Technical Advisory Bulletin (TAB)

Bulletin #: TBMELCO10A

Product: Melco EMT16, BRAVO

Subject: Hook Adapter Flange, P/N 34326

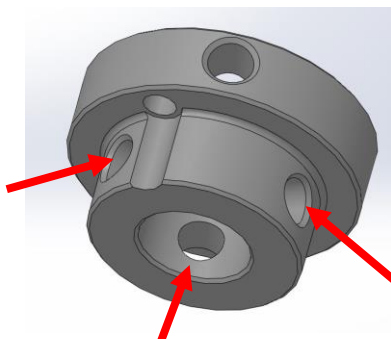
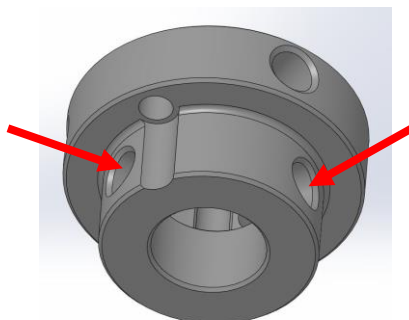
The production Hook Adapter Flange, P/N 34326, currently assembles to the bobbin shaft using (3) set screws as shown below. After these set screws are tightened, the hook can sometimes run eccentric and wobble as it rotates. This can have a direct effect on setting and maintaining hook timing and hook gap.

The new Hook Adapter Flange, P/N 34326, has been modified and now has (2) set screws instead of (3) as shown below. Tightening only 2 set screws has been found to minimize hook eccentricity and wobble, thereby maintaining consistent hook timing and hook gap settings during sewing.

- If a technician experiences excessive hook eccentricity or wobble, they can try two things.
 - One, reset hook timing and only tighten 2 of the 3 set screws that hold the Hook Adapter Flange to the bobbin shaft. The third set screw should be removed and discarded.
 - Two, they can order the new Hook Adapter Flange having only 2 set screw locations and set hook timing as originally instructed.
- NOTE: The set screw locations on the new Hook Adapter Flange are now located so that all set screws can be accessed and tightened when setting both hook timing and hook gap as shown below. No longer does the hook need to be rotated when tightening all the set screws.
